Form 3160-5  
(June 2019)

SUNDRY NOTICES AND REPORTS ON WELLS  
Do not use this form for proposals to drill or to re-enter an abandoned well. Use Form 3160-3 (APD) for such proposals.

8. Well Name and No.  
IGOR 33 FED COM/702H

EOG respectfully requests an amendment to our approved APD for this well to reflectthe following changes:

WELL LOCATION AND ACREAGE DEDICATION PLAT

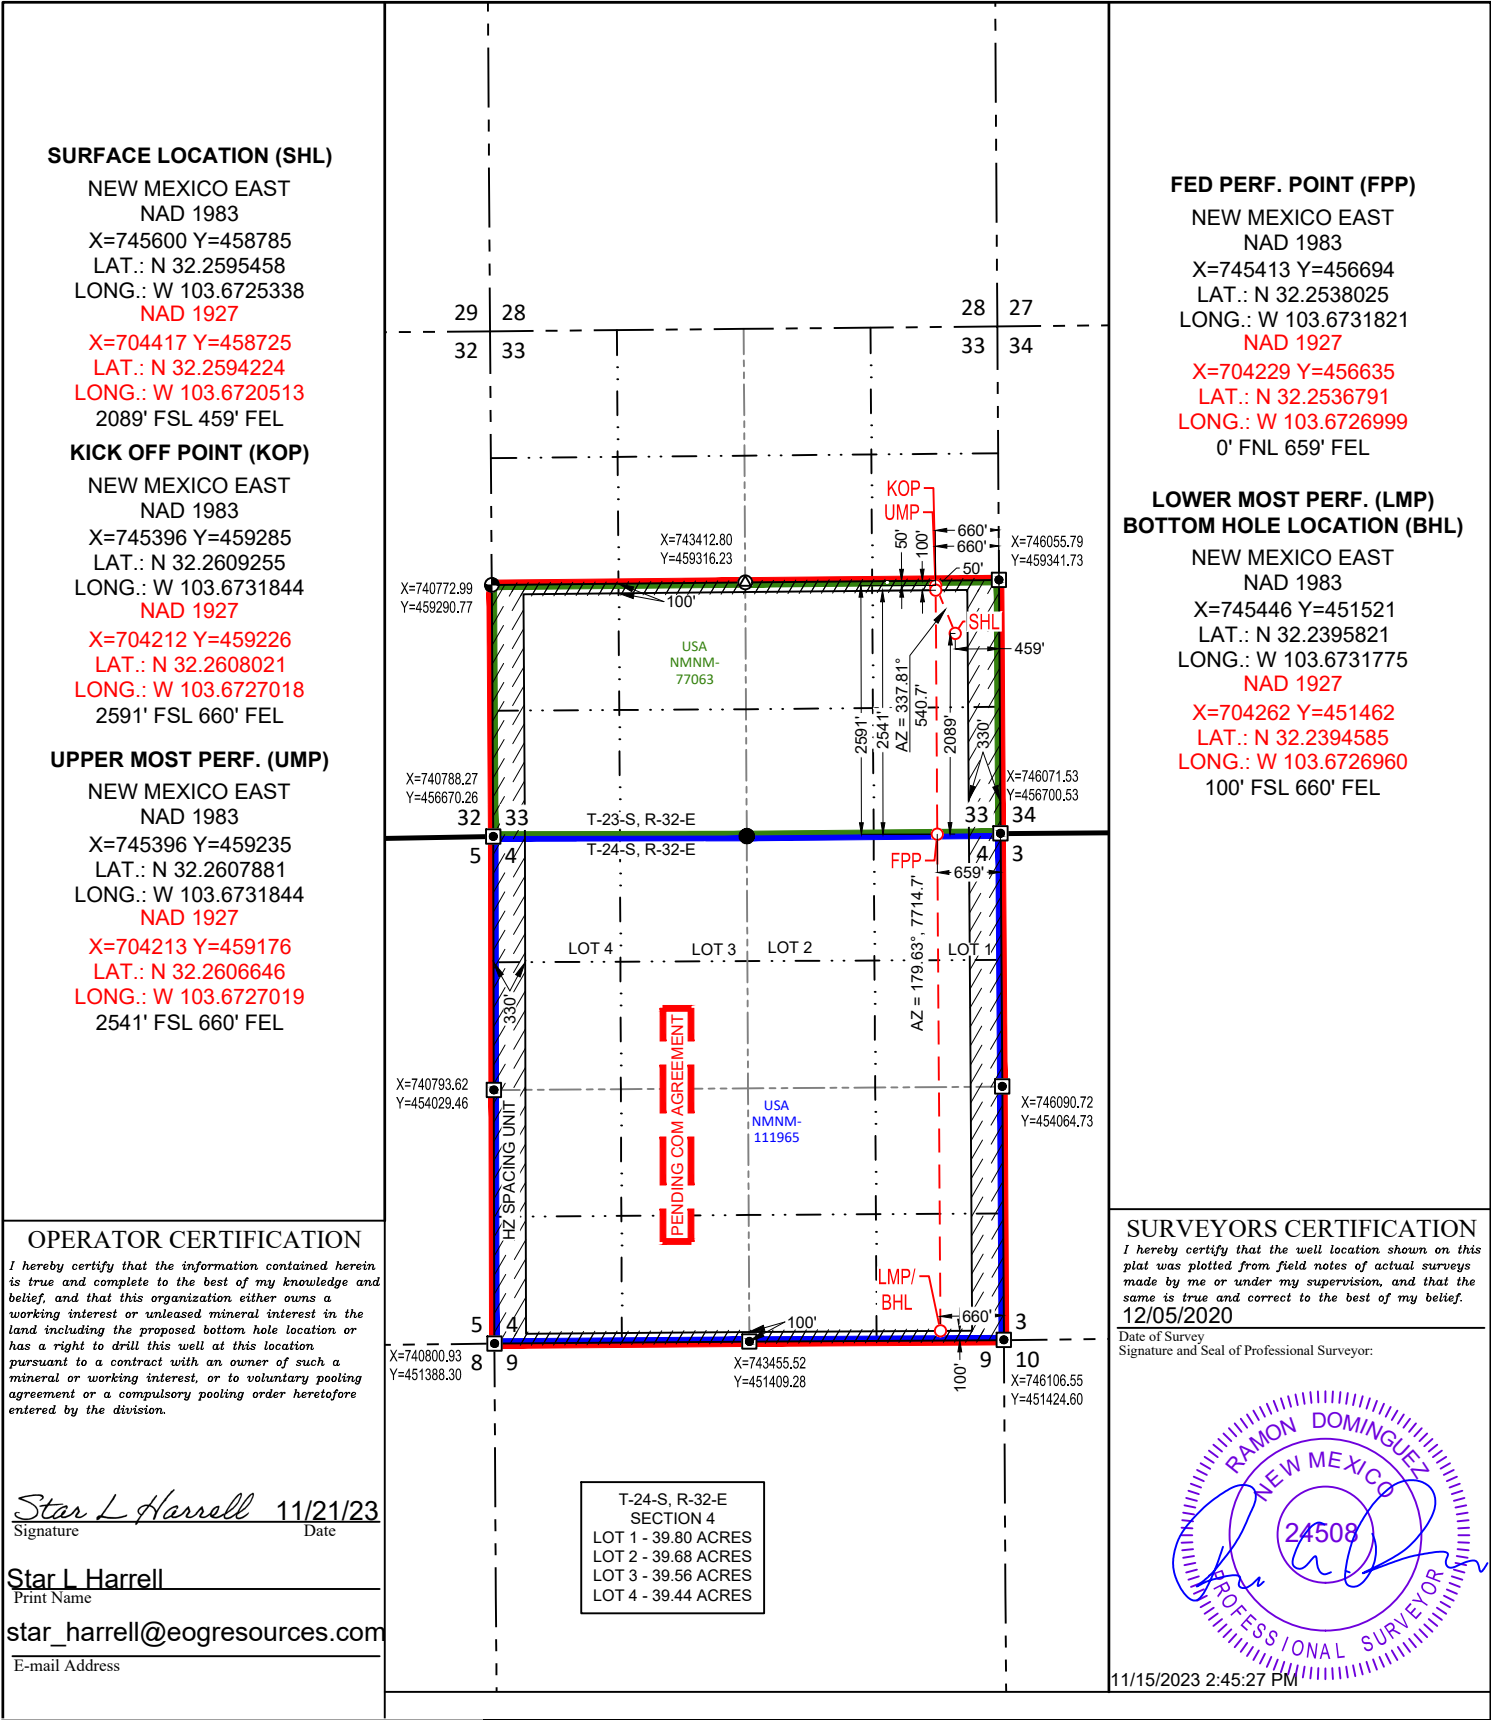
Inga 33 Fed Com 512H (FKA Igor 33 Fed Com 702H) API #: 30-025-51724

Change name from Igor 33 Fed Com 702H to Inga 33 Fed Com 512H.

Change SHL from T-23-S, R-32-E, Sec 33, 244' FSL, 1052' FEL, Lea Co., NM, to T-23-S, R-32-E, Sec 33, 2089' FSL, 459' FEL, Lea Co., N.M.

Change BHL from T-23-S, R-32-E, Sec 28, 100' FNL, 830' FEL, Lea Co., NM, to T-24-S, R-32-E, Sec 4, 100' FSL, 660' FEL, Lea Co., N.M.

Update the Pool as reflected in the C-102.

Revised Wellbore A:

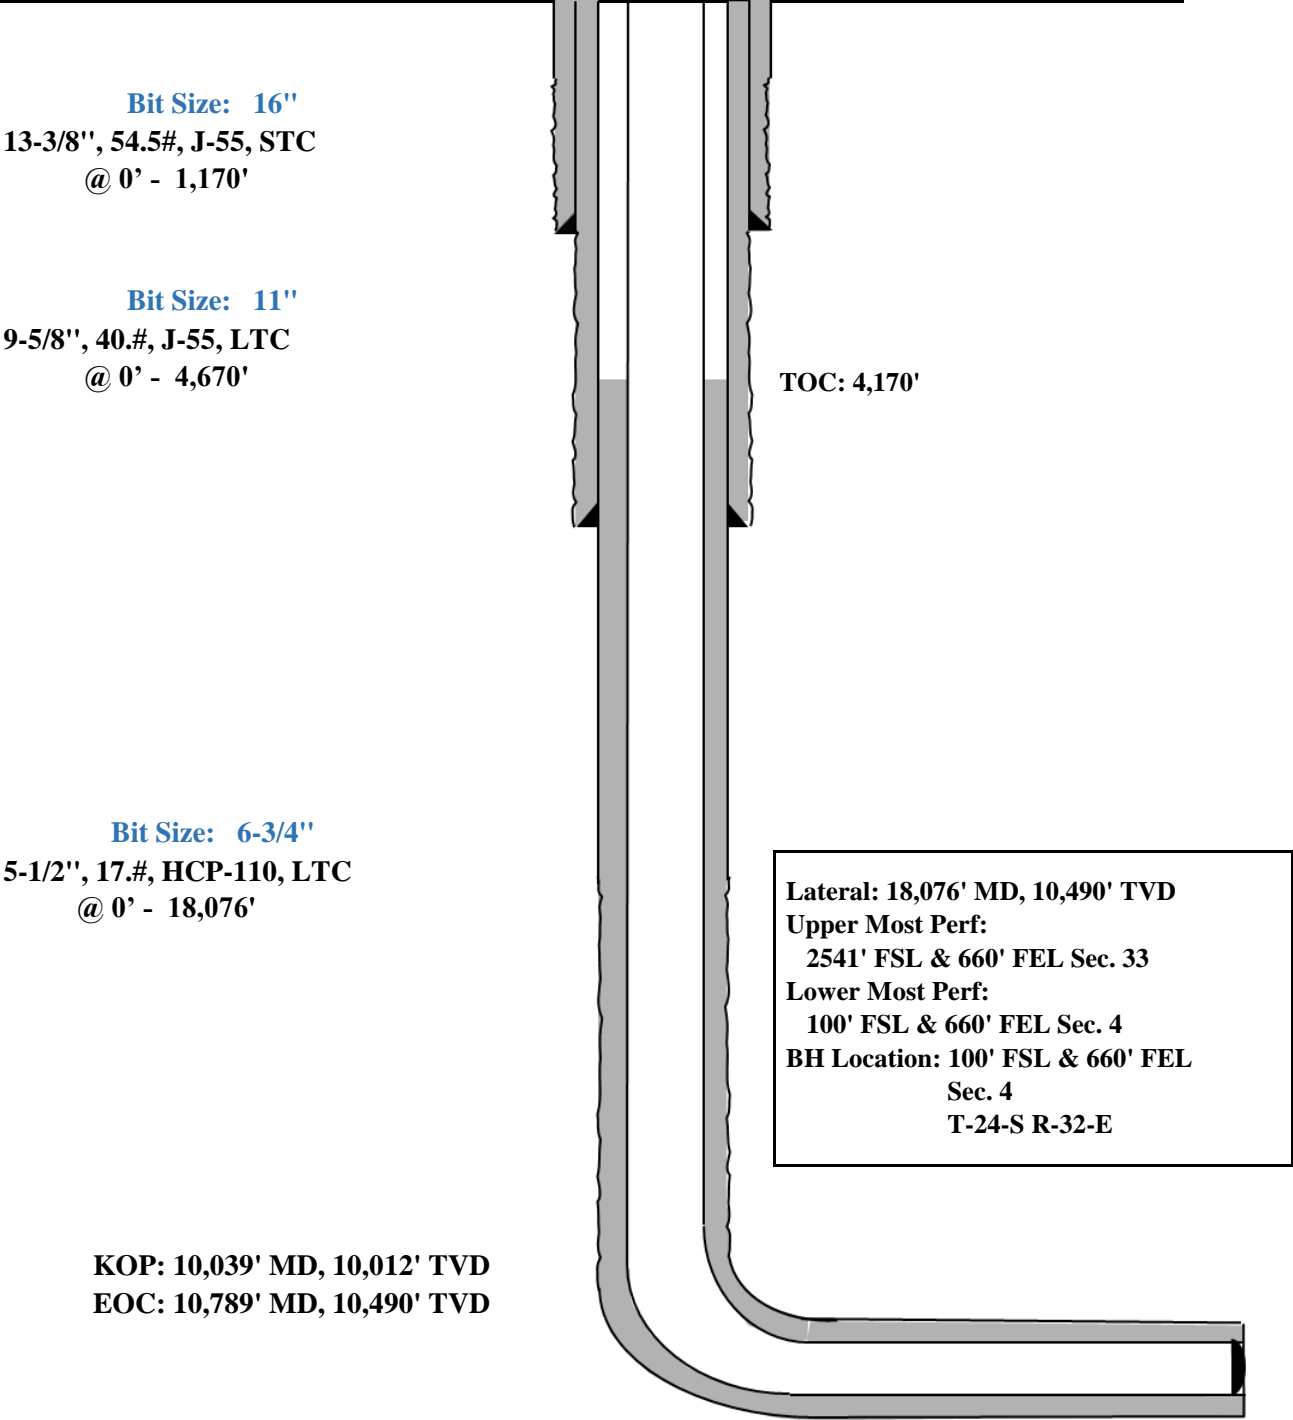
Update casing and cement program to current design.

**Casing Program A:**

Variance is requested to waive the centralizer requirements for the 9-5/8" casing in the 11" hole size. An expansion additive will be utilized, in the cement slurry, for the entire length of the 11" hole interval to maximize cement bond and zonal isolation.

Variance is also requested to waive any centralizer requirements for the 5-1/2" casing in the 6-3/4" hole size. An expansion additive will be utilized, in the cement slurry, for the entire length of the 6-3/4" hole interval to maximize cement bond and zonal isolation.
